September 10, 1997

3435.00-005

Subject: Response to Chiron Comments for the Site Investigation Workplan
Sherwin-Williams Facility, Emeryville, California

Figure Background source:
 From June 20, 1997 comments by Erler & Kalinowski, Inc.,
 Maximum Arsenic Concentrations Detected in Soil (Based
 on Data Collected as of 15 April 1997)
 Chiron, Emeryville, CA, April 1997, EKI 970001.85, Figure 1.

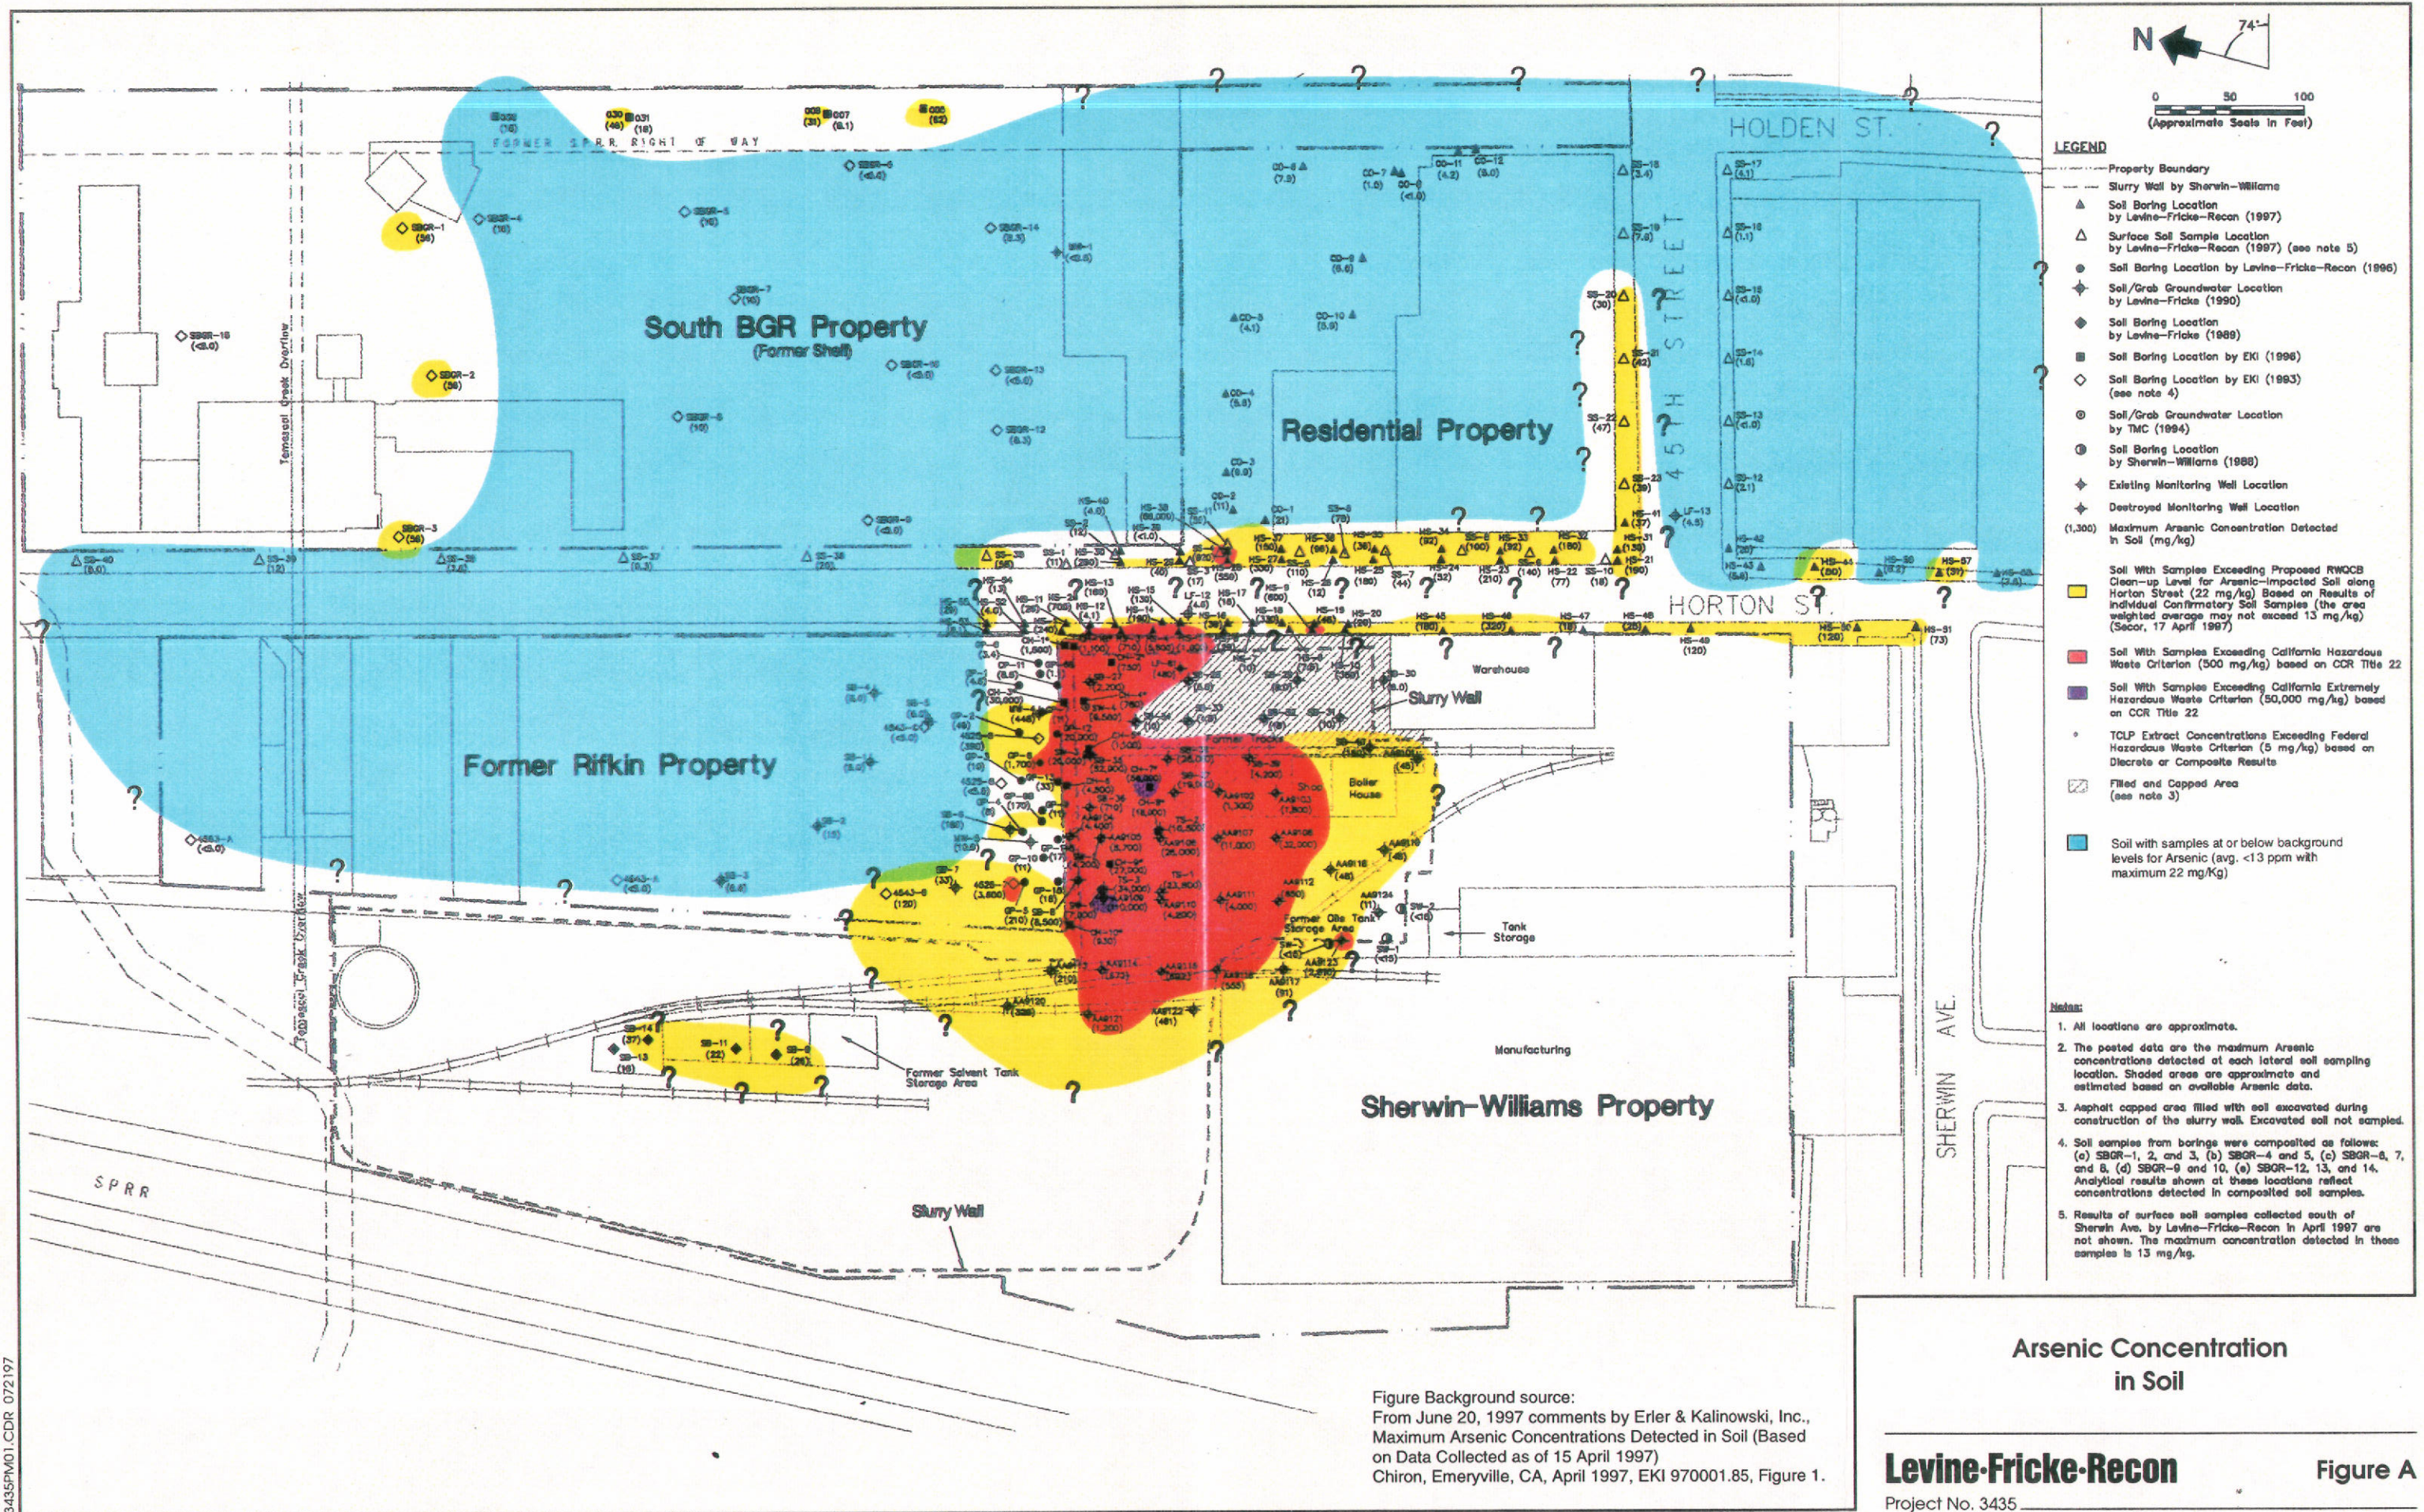
- EKI prepared a figure contouring arsenic concentrations in soil, which was included in their comments (Attachment C of the June 20, 1997 EKI comments letter). EKI claims that SW should do more investigation on the South BGR property since the property used to be an open field during the time of SW's past lead-arsenate operations and because arsenic was detected at elevated levels in several soil borings in the northern and eastern part of the property. We have taken EKI's figure and added a highlight of the area of soils where arsenic is at or below

background levels (see blue highlight on figure in Attachment D). Since south BGR was formerly an open field, one would expect the soils closer to SW to be impacted if in fact the elevated samples to the north and east were from a SW source. In fact, this is not the case and clearly the data does not support EKI's claim.
